Response to Reviewer 1

This paper introduces a new method for quantifying storm hazards and their effect on building habitability, specifically in the context of Hurricane Irma. The proposed methods offer some insight into how hazard levels (e.g., water depth, flow velocity, etc.) can be used to estimate the probability of a building becoming uninhabitable following the hurricane. However, there are several missing discussions and insights.

Reviewer Figure 1: Box plots of the maximum depth (a), flow speed (b), significant wave height (c), unit discharge (d), total depth (e), flow momentum flux (f), wave energy flux (g), and total force (h) used to develop habitability functions for Collier and Monroe counties.

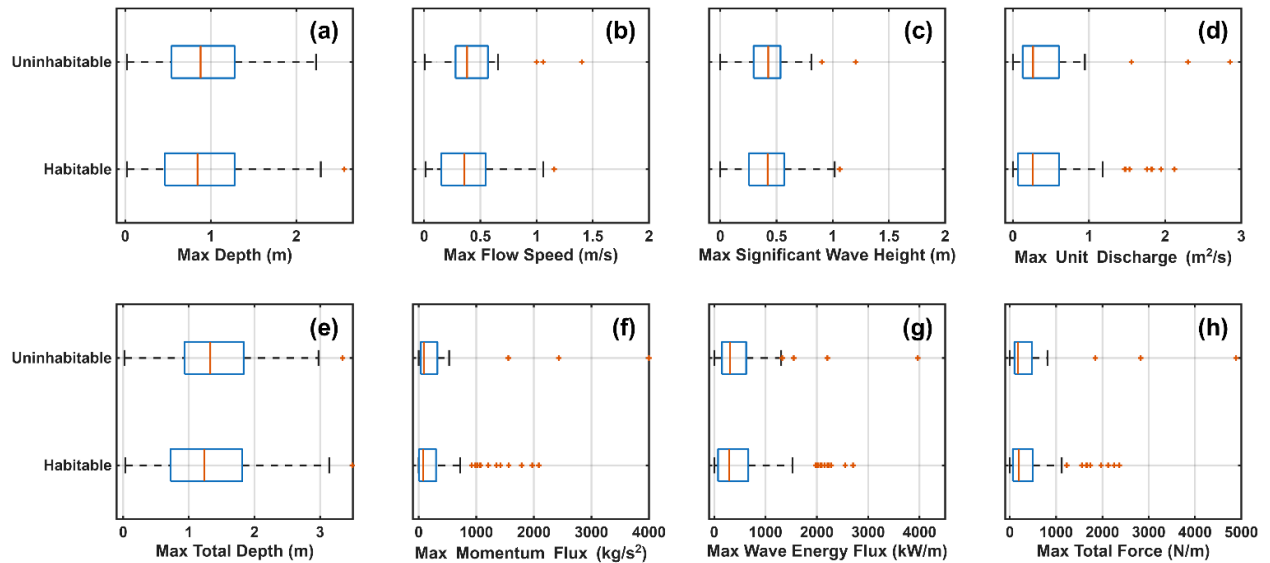
Despite statistical significance, there is substantial overlap between habitable and uninhabitable buildings, which undermines confidence in hazard level as a strong predictor of uninhabitability.

We concur with the reviewer's comment that there is overlap between the hazard levels experienced by habitable and uninhabitable buildings. To give greater confidence to using hazard levels to predict uninhabitability, we have included box plots that give greater detail on the hazard levels used for the habitability functions (Reviewer Figs. 1-3), showing differences in the distribution of hazard levels for habitable and uninhabitable buildings. We have included these box plots in the revised manuscript as Figs. A3, B3, and B4.

Review Figure 4: Sensitivity of habitability curves for both Monroe and Collier Counties for five different return-date thresholds.

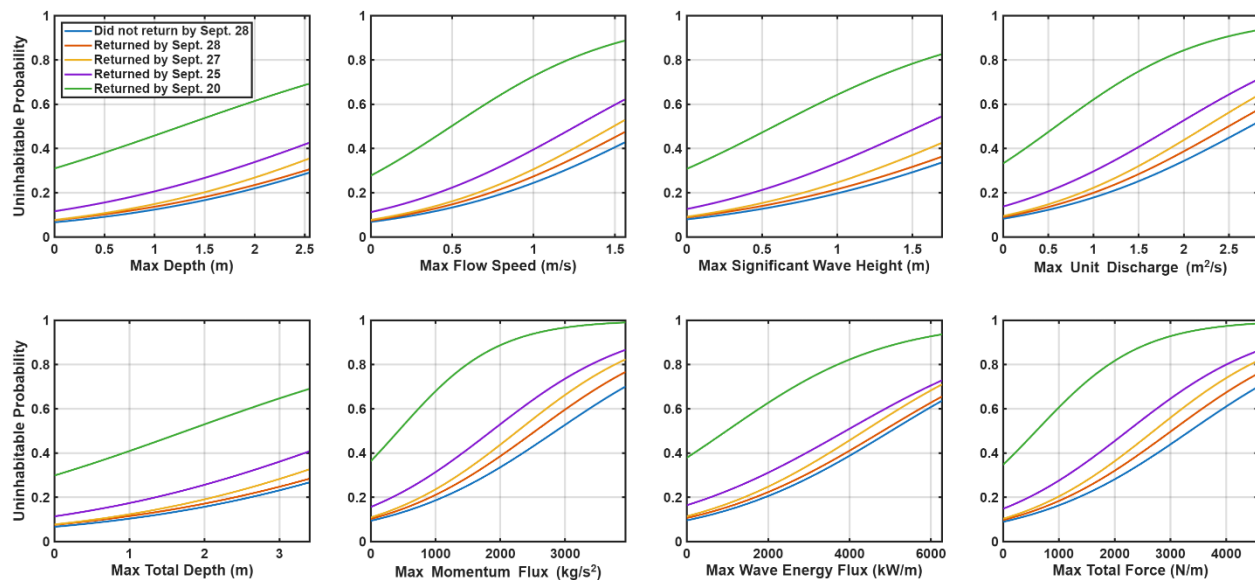
Several improvements could strengthen this work: increase the sample size by including more regions, hurricanes, or buildings; revisit and expand the discussion of model limitations; clarify the assumptions behind using cell phone data as a proxy for habitability; and test whether altering the return-date threshold affects the results.

As the Reviewer suggests, we have tested whether altering the return-date threshold affects the results (Review Fig. 4). With the data utilized in this study, we only have access to earlier return-date thresholds, so we tested setting the threshold to returned by September 28th, 27th, 25th, and 20th, where the threshold used in the study are those that did not return by the 28th. As expected, this does change the habitability functions, shifting each habitability function towards greater uninhabitable probabilities. This is understandable since setting the return-date threshold to earlier dates is just changing habitable entries to uninhabitable. While we cannot test the opposite impact of making the return-date threshold later, it can be inferred that we would see the habitability functions shift towards lower uninhabitable probabilities.
